Our Ref: 25-241
6 May 2026

RESPONSE TO INFORMATION REQUEST – A006826070
415 MILTON ROAD, AUCHENFLOWER QLD 4066

We refer to Council's Information Request dated 4 September 2025 and respond to the issues raised as follows.

Figure 1 – Building separation distances

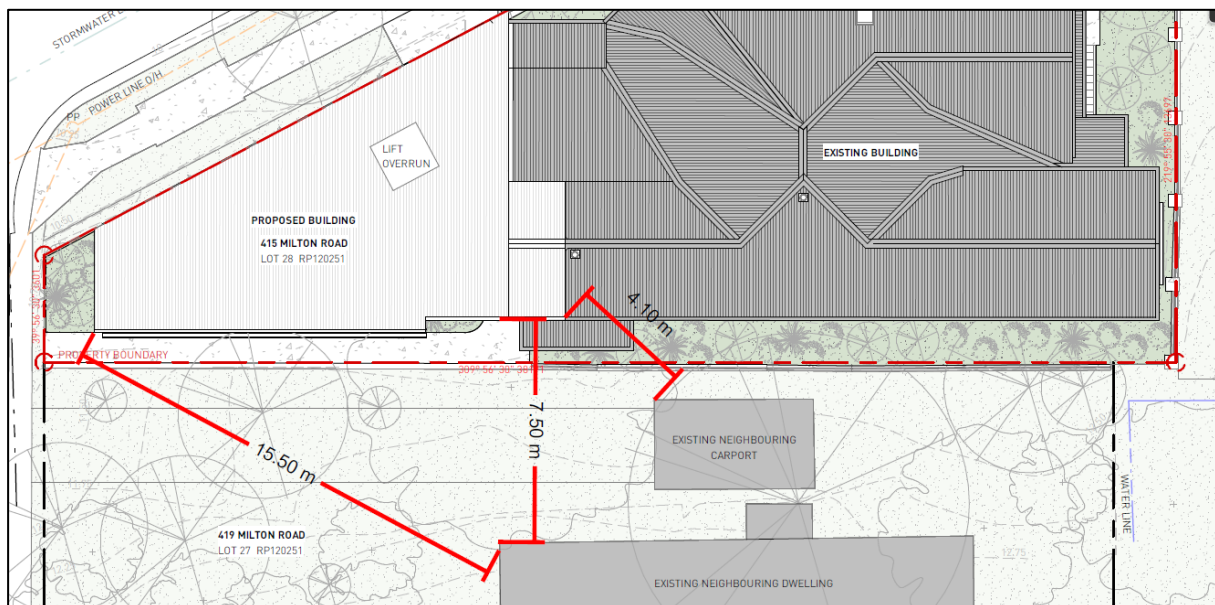
3. Side Boundary Setback

Amend the side boundary setback of the proposed extension to comply with Acceptable Outcome AO8.1 of the Small-scale non-residential uses code or demonstrate that the proposed development complies with Performance Outcome PO8 of the code.

Response:

Please refer to the Architectural Plans prepared by Petrie Architecture which includes an amended Site Plan to include the adjoining lot and Dwelling House. The revised plans also

include an additional Section Plan which highlights the slope of the sites and proximity of the extensions to the adjoining property.

The proposed extensions do not overlook or overshadow the residential dwelling as a result of the slope of the land and the existing landscaping.

The sloping topography ensures that the proposed extensions are located downhill from the adjoining Dwelling House, and as such will not cause a significant reduction in access to daylight or breezes.

Further, it is noted that the adjoining Dwelling House is located towards the southern end of the site, and the proposed extensions are located at the northern end of the site, so there is significant separation between the uses. The proposed extensions directly adjoin the driveway of the adjoining Dwelling House.

The proposed setback is considered suitable given the context of the existing use, the land uses in the area, and the slope of the land.

The building separation distances are identified in Figure 1 below.
